FIELD SERVICE BULLETIN

FSB Number: LVCCFSB2005-365
Author: Tony Bryan
Date: January 03, 2006
Total No. of Pages: 3
Subject: GSM PEBL U6 – Battery Contact Alignment
Phone Models: GSM PEBL U6 – SJUG10xxAA and SJUG16xxAA
Level of Repair: 2

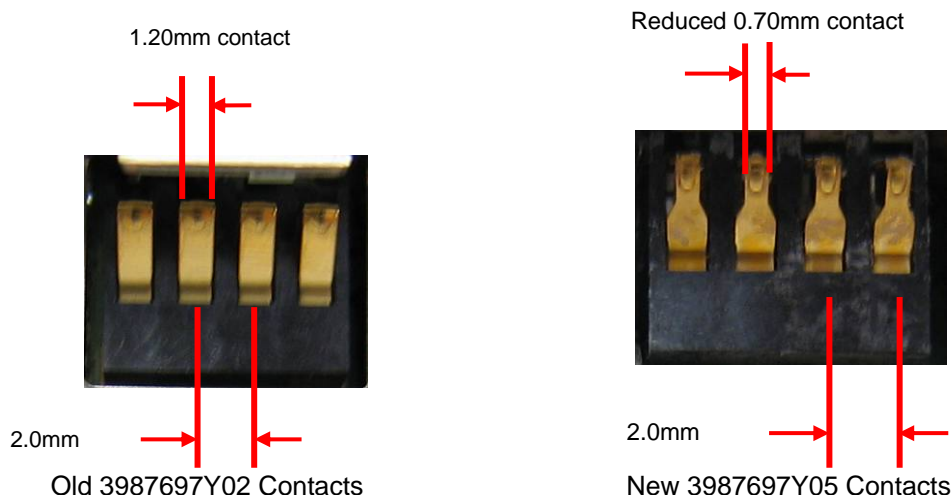
Service is aware of a pre-launch issue on GSM PEBL U6 phones that could potentially cause customers to return units with complaints related to No Turn On. The root cause of the issue is that the width of the PCB battery contacts closely matches the width of the contacts on the battery. When installing the battery, there is a potential for improper battery to battery contact alignment. When this occurs the PCB contacts may rest on the battery pack insulator ribs, preventing power and causing the customer to experience a No Turn On failure.

Short-Term: Prior to product launch, a thin strip of lexan material was added to the battery cavity as a shim to help ensure proper battery to battery contact alignment. See Image Below.

Long-Term: The M1400 battery contacts have been redesigned to eliminate this failure mode. The new part number 3987697Y05 replaces the old part number 3987697Y02 for reference designator M1400. See Images Below.
